CITY OF MANHATTAN BEACH
COMMUNITY DEVELOPMENT DEPARTMENT

801 North Sepulveda Blvd.

Subject: Appeal of Paragon Project Resolution No. PC 17-01, Summary

**PARAGON'S POLE SIGN
ABANDONED AND
NOT PERMITTED**

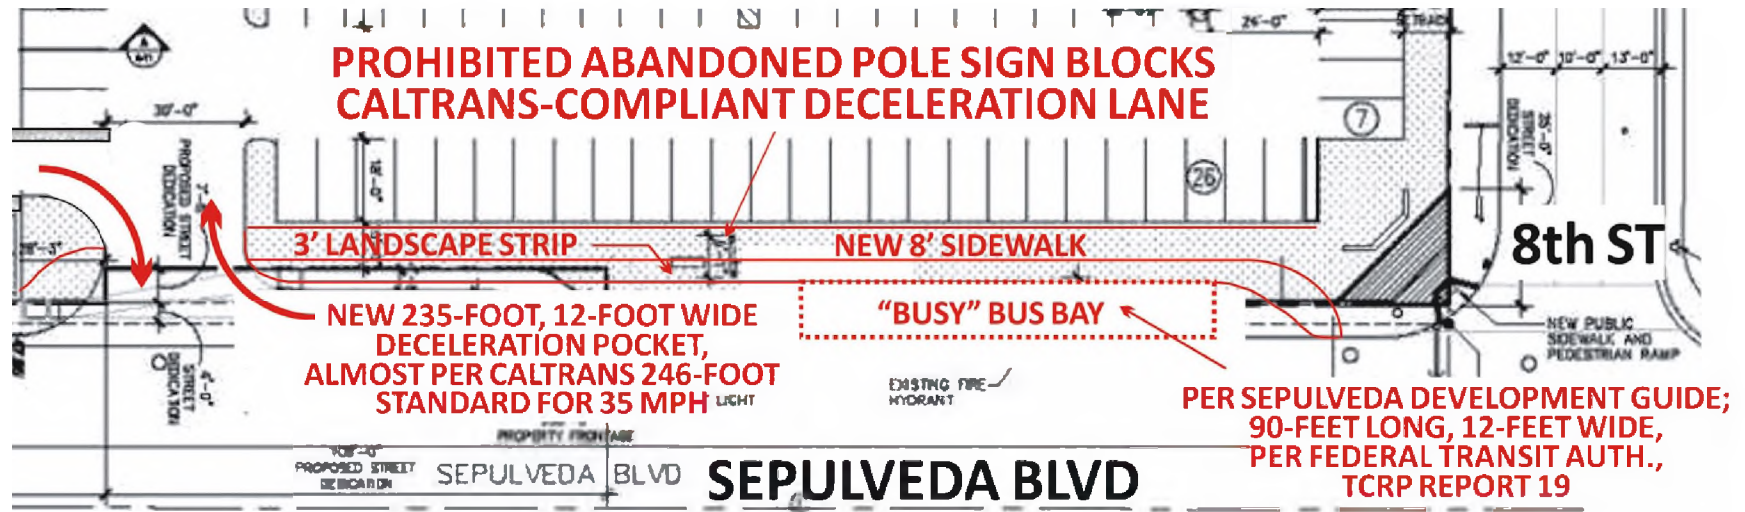
Exhibit 3 shows the deceleration-lane detail, provided in the approved plans. Notice that Paragon ended the deceleration lane just short of the prohibited existing pole sign. The sign would otherwise encroach into the deceleration lane.

The Paragon lane has 10.5-foot width compared to the Caltrans 11-foot minimum requirement, as well as 110-foot length, compared to the 246-foot requirement.

**OUR DECELERATION LANE COMPLIES WITH SEPULVEDA DEVELOPMENT GUIDE & CALTRANS
STAFF APPROVED THE PARAGON NONCOMPLIANT LANE TO RETAIN THE PROHIBITED ABANDONED POLE SIGN**

**BUS STOP IN OUR DECELERATION LANE COMPLIES WITH SEPULVEDA DEVELOPMENT GUIDE
PARAGON DECELERATION LANE VIOLATES SEPULVEDA GUIDE & CALTRANS STANDARDS**

Exhibit 5 shows a deceleration lane design that complies with the Sepulveda Blvd. Development Guide and Caltrans standards. The design does not impact Paragon's parking lot, but it does require demolition of the prohibited pole sign and provides the required bus turnout. At the March 22 hearing, Mr. Zandvliet testified the site can accommodate such a 12-foot wide deceleration lane, extending almost to the 246 feet stipulated by Caltrans.

EXHIBIT 7.

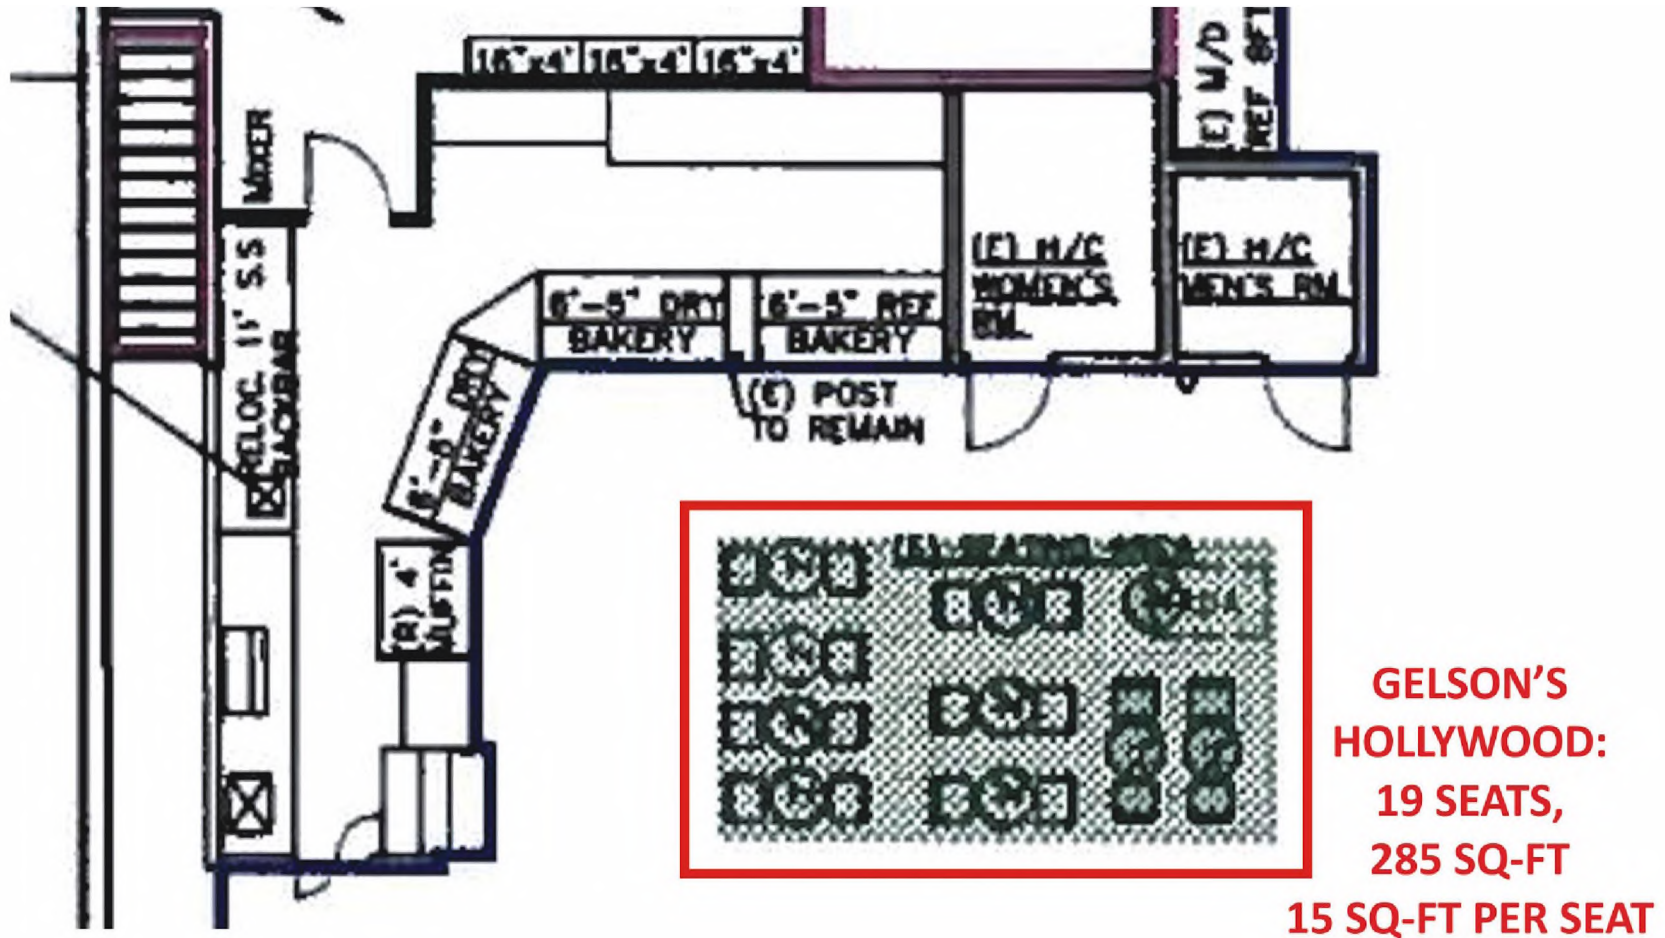
Exhibit 7 shows the seating density in Gelson's Hollywood store. It comes out 15 sq-ft per chair, as permitted by the state building code¹. Per Exhibit 8, in the approved plan for the Manhattan Gelson's, Paragon cut the number of chairs in half, by using 31 sq-ft per chair compared to 15 sq-ft in the Hollywood store and permitted by state code.

PARAGON GAMED DINING PARKING BY REDUCING NUMBER OF SEATS

GELSON'S HOLLYWOOD STORE SEATING DENSITY: 15 SQ-FT PER SEAT. [See below]

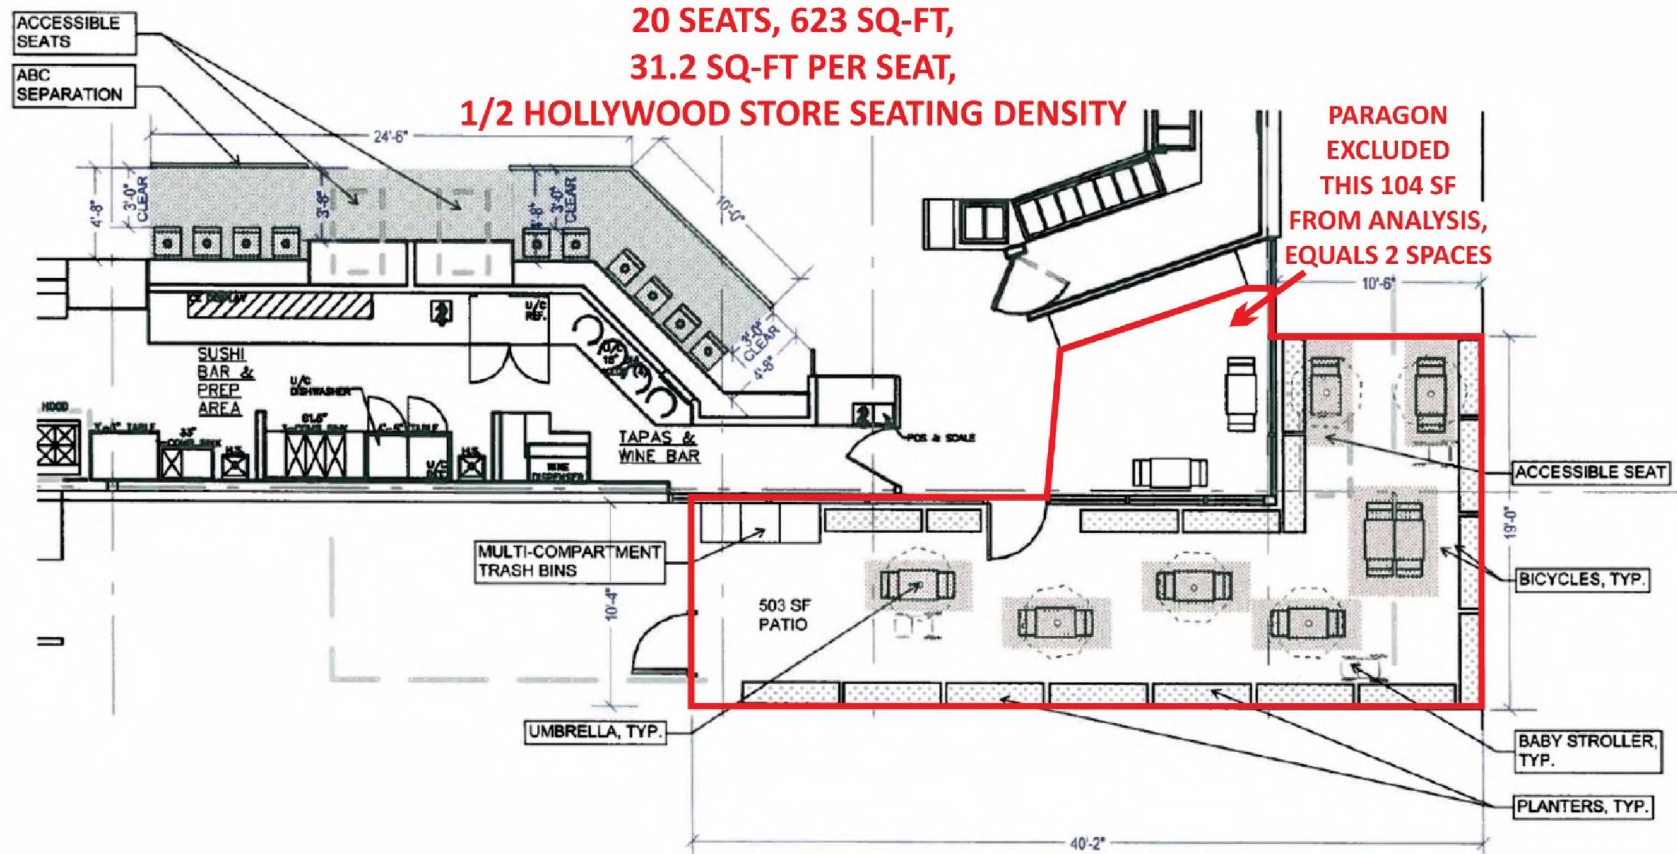
PARAGON FURTHER GAMED PARKING BY ANALYZING 28 SEATS VS 32 SEATS ON PLAN BELOW

NOTE: USE PERMIT SPECIFIES EATING AREA, NOT SEATS.

GELSON'S WILL DOUBLE SEATING AND THEREFORE DOUBLE REAL PARKING DEMAND.

EXHIBIT 4.

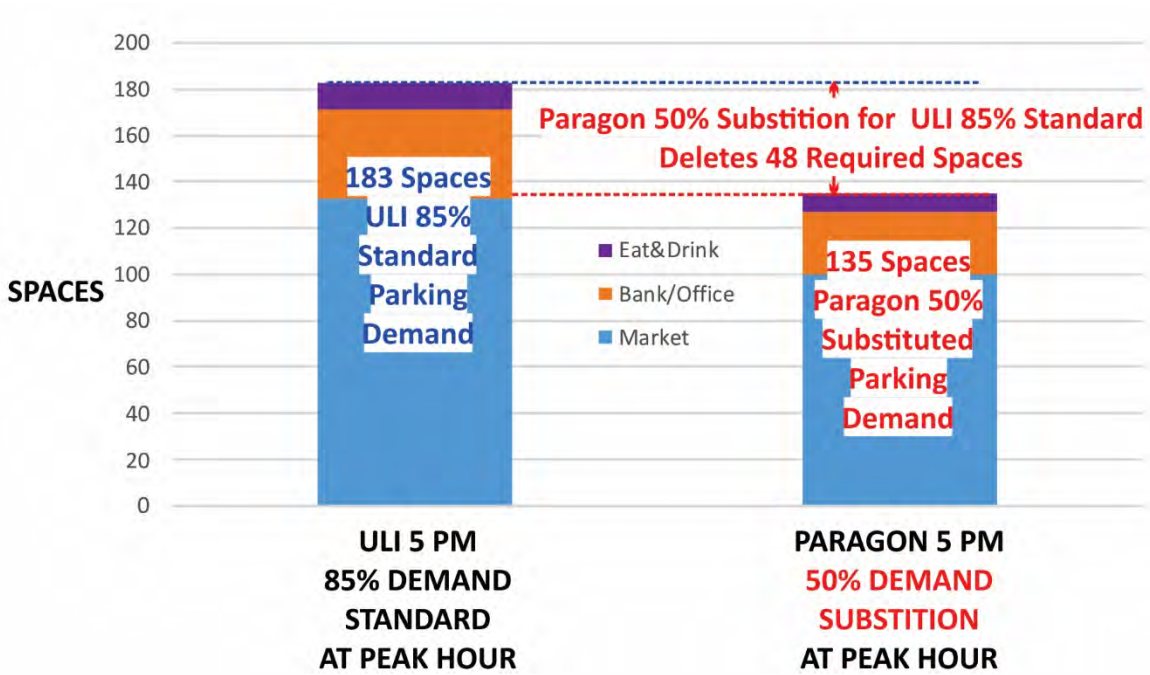
Exhibit 4 shows that using the correct ULI/ITE peak demands versus Paragon’s average demands results in a total of 183 spaces required at peak time, versus Paragon’s 135.

PARAGON AVERAGE-DEMAND SUBSTITUTION DELETES 48 SPACES

**THE 50% SUBSTITUTION NOT SPECIFIC TO THE PARAGON PROJECT
ALL DEVELOPERS CAN AND WILL INSIST ON THE SAME REDUCED PARKING!**

EXHIBIT 5.

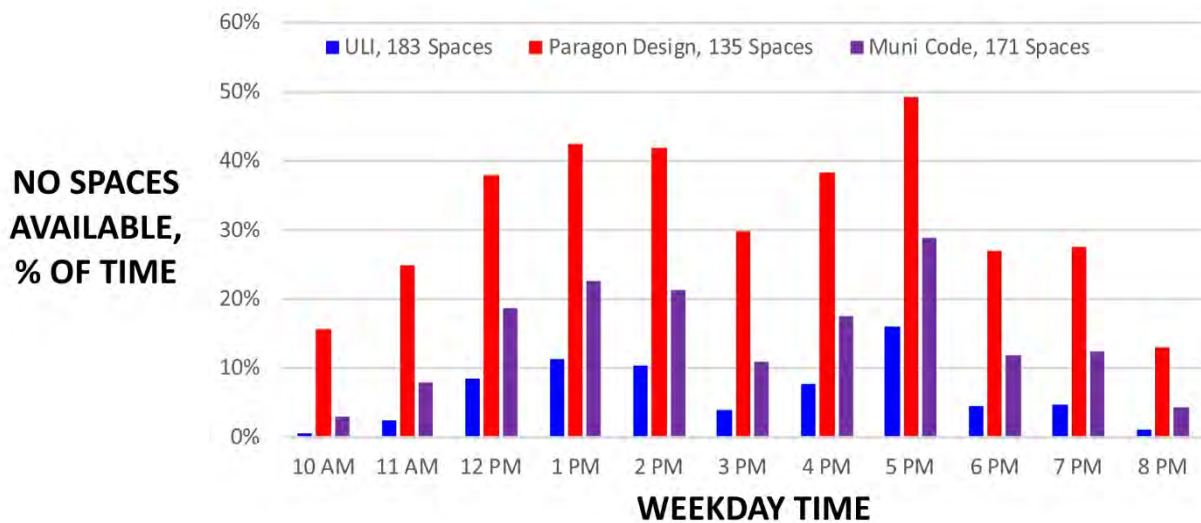
PARAGON PARKING AND TRAFFIC WILL GO TO RESIDENTIAL STREETS 25% TO 50% OF THE TIME

EXHIBIT 6.

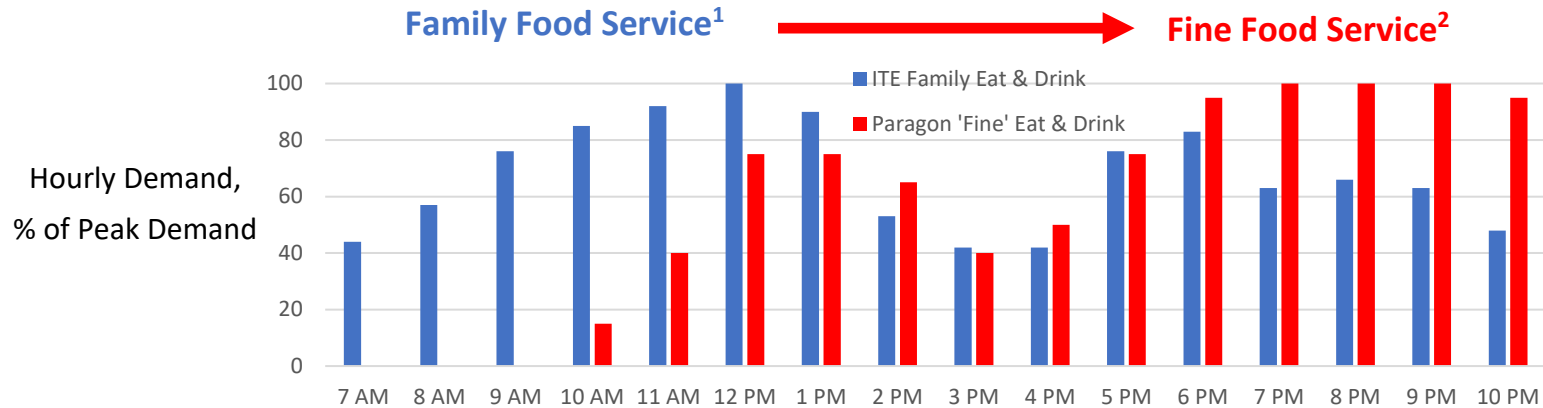
PARAGON USED 'FINE' DINING TIMELINE TO SHIFT PARKING AFTER BANK 6 PM CLOSE

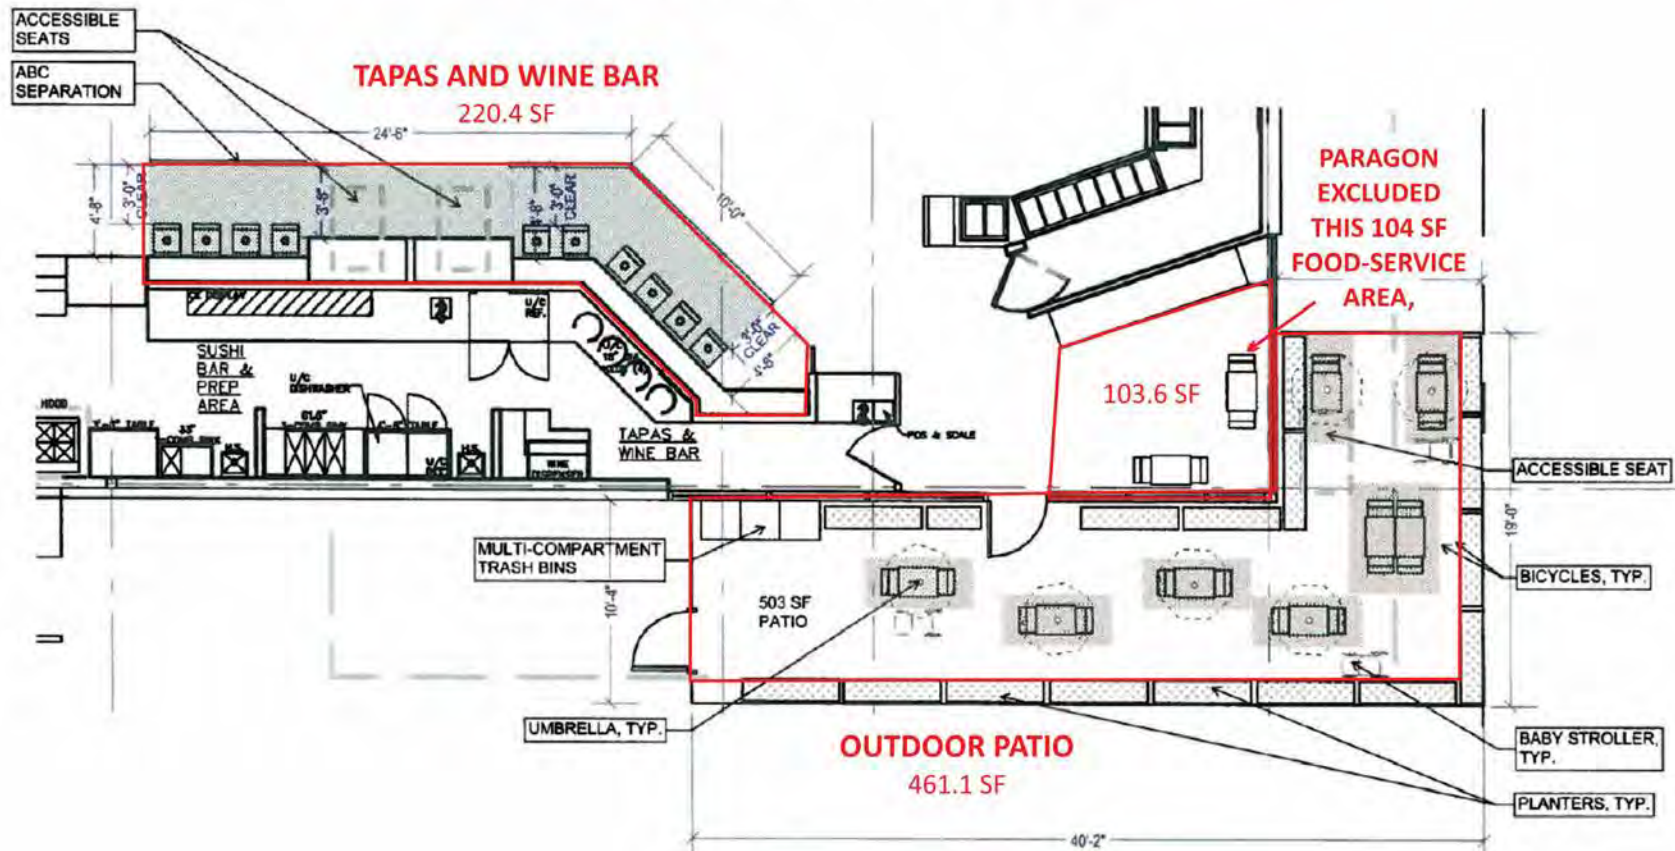
PARAGON FURTHER GAMED PARKING BY ANALYZING 28 SEATS VS 32 SEATS ON PLAN BELOW

**NET INDOOR-OUTDOOR EATING & DRINKING AREA, 785 SF,
16 PARKING SPACES @ 1 PER 50 SF FOR SIT-DOWN VS PARAGON'S 10 SPACES**

EXHIBIT 8.

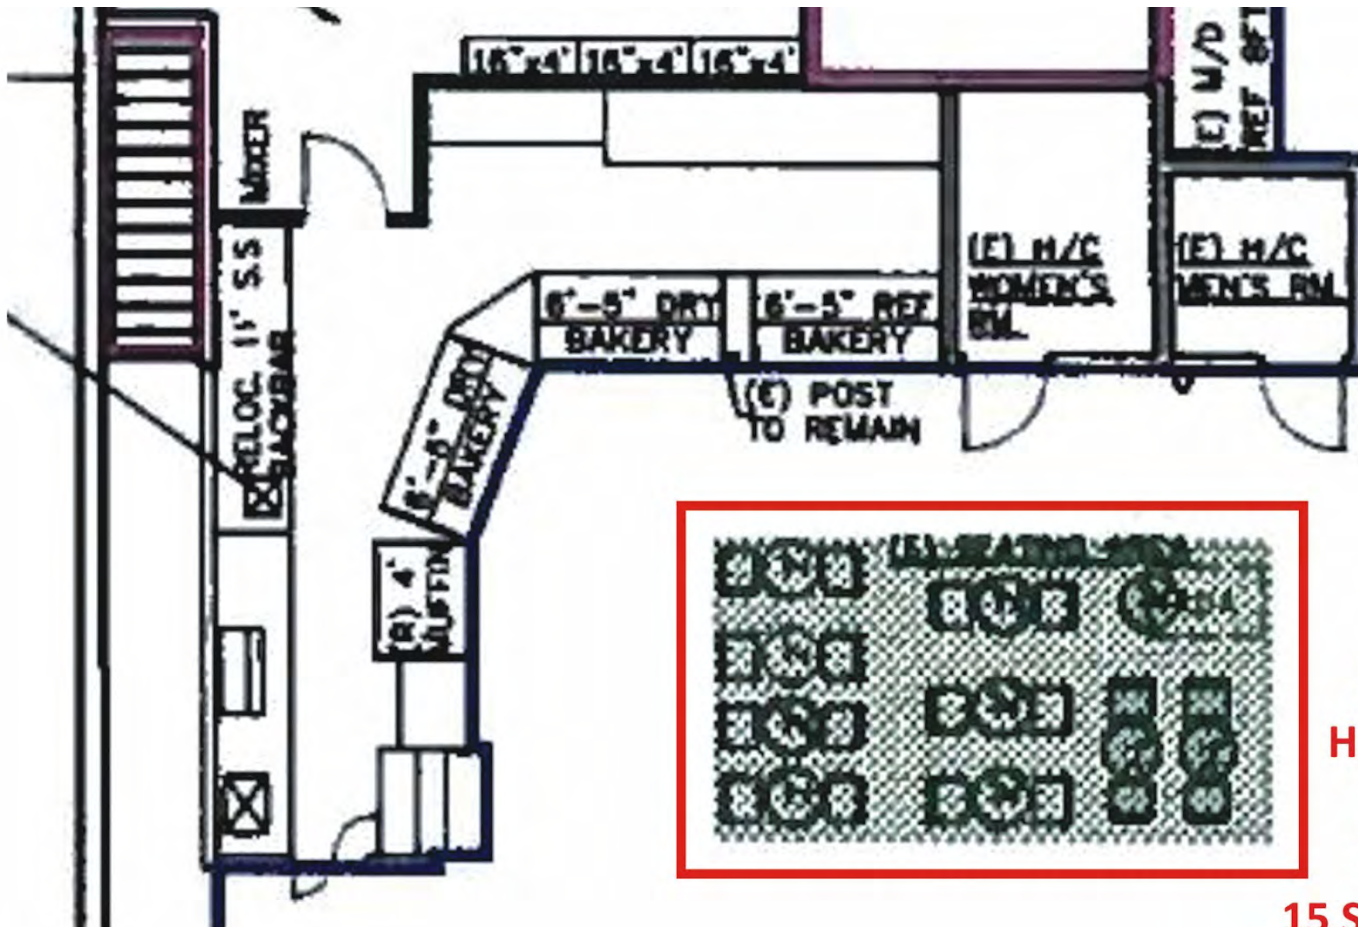
PARAGON GAMED FOOD-SERVICE PARKING BY REDUCING NUMBER OF SEATS

- GELSON'S HOLLYWOOD STORE SEATING DENSITY: 15 SQ-FT PER SEAT. [See below]
- GELSON'S MANHATTAN STORE SEATING DENSITY: **31 SQ-FT PER SEAT**. [See next slide]
- STATE BUILDING CODE REQUIRES 15 SQ-FT MINIMUMS PER SEAT [Title 24, Part 2, Chapter 10, Table 1004.1.1]

NOTE: PARAGON CALCULATES PARKING **PER SEAT**. THE APPROVED USE PERMIT SPECIFIES PARKING BY AREA. GELSON'S WILL PACK THE FOOD AREA WITH CHAIRS, ADDING 8 MORE SPACES TO PARKING DEMAND.

EXHIBIT 12.

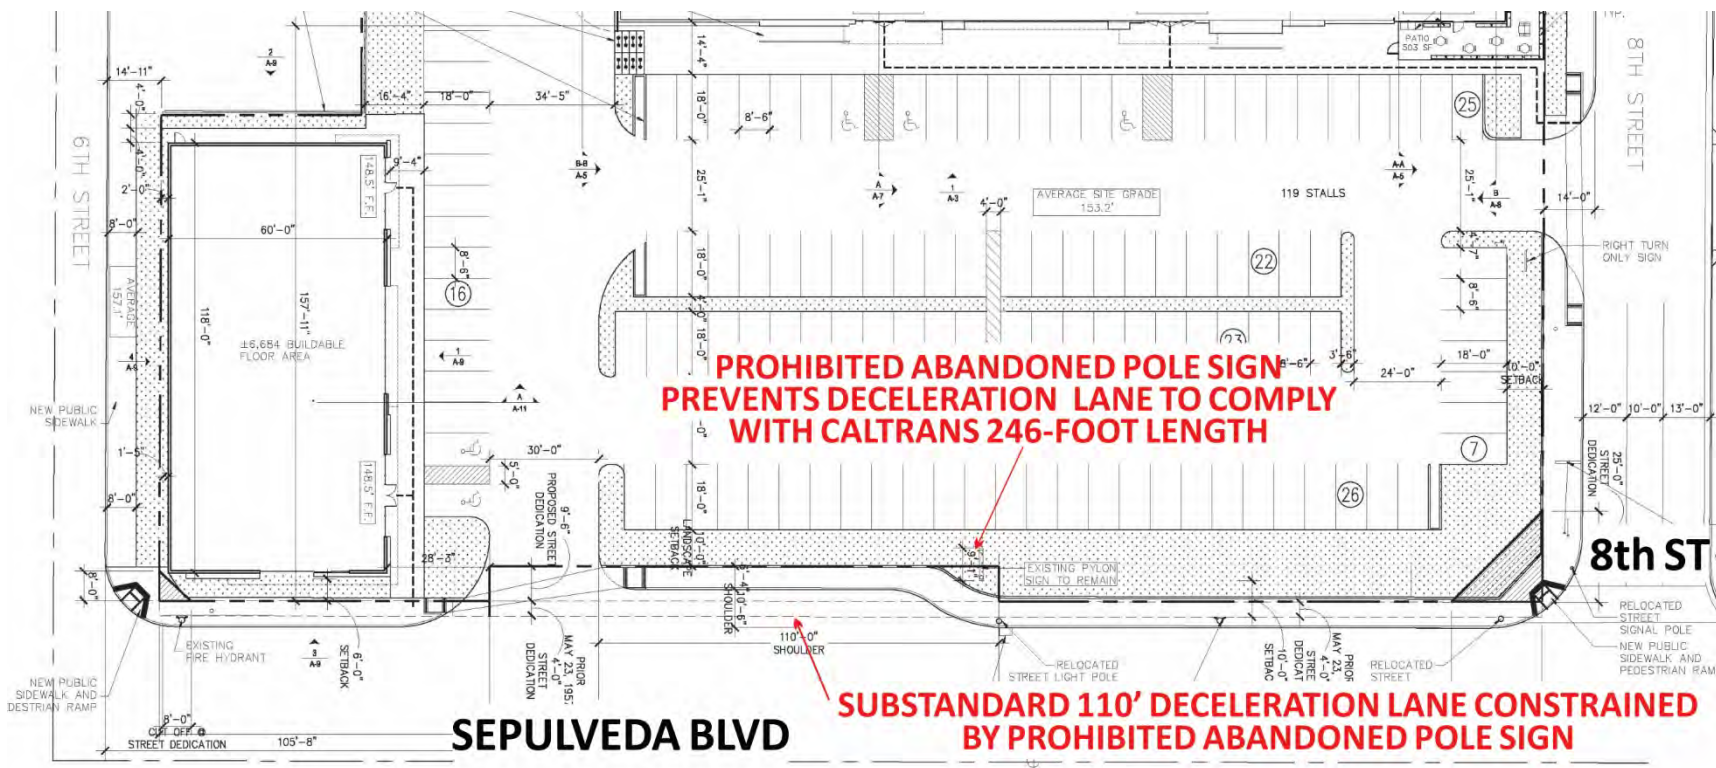
The approved Paragon plans intrinsically link the inadequate and dangerous deceleration lane with the prohibited abandoned pole sign. The 29-foot high sign blocks extension of the deceleration lane, required for compliance with Caltrans standards and the *Sepulveda Blvd. Development Guide*. [Approved plan, Exhibit 12]

PROHIBITED POLE SIGN BLOCKS DECELERATION LANE COMPLIANCE WITH CALTRANS STANDARDS
